BCA ASSESSMENT REPORT

Stage 3 SSD, Sydney Business Park, Marsden Park

Prepared For:
Sydney Business Park

Date: 23 July 2020

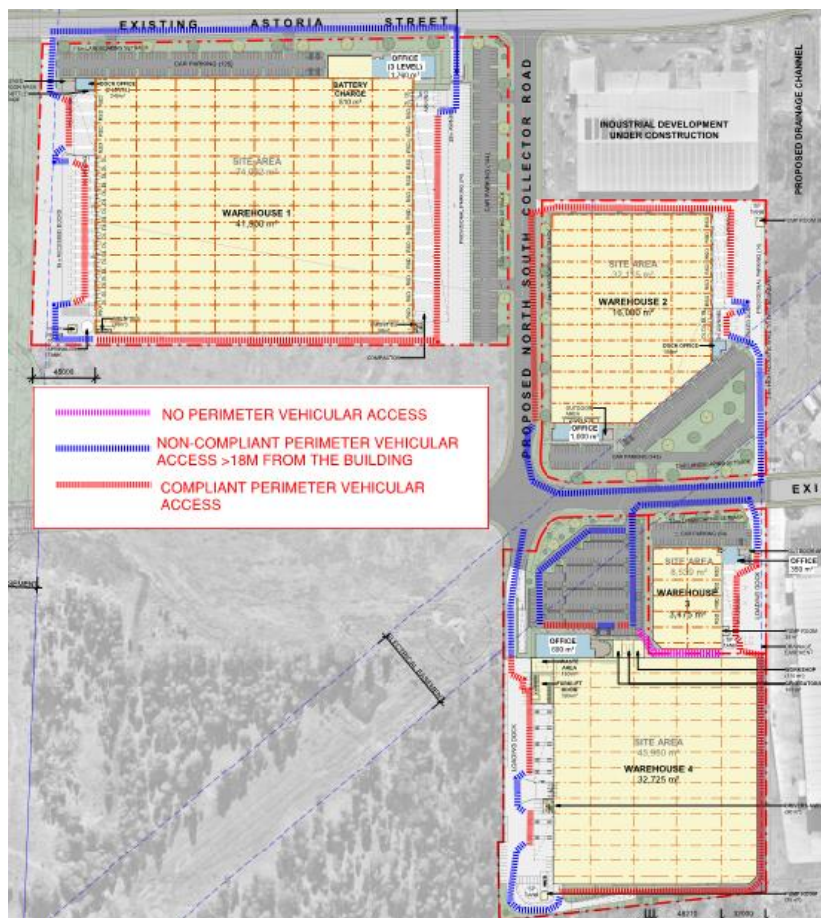
Comments: The proposed warehouse buildings do not comply with the provisions of C2.4 and thus the following non-compliance areas are identified on the site plan that are required to be addressed as an Performance Solution by the Fire Safety Engineer for each building:

Note 1: The driveways providing vehicular perimeter access must be designed with adequate loading capacities to withstand a fire truck and the gradients of the ramps should take into consideration to the FRNSW Policy 4 Vehicular Access Guideline.

Note 2: If the perimeter access paths are reduced to less than 6m in width to accommodate pedestrian egress paths per Clause D1.10 below, this will need to be documented in the Performance Solution.
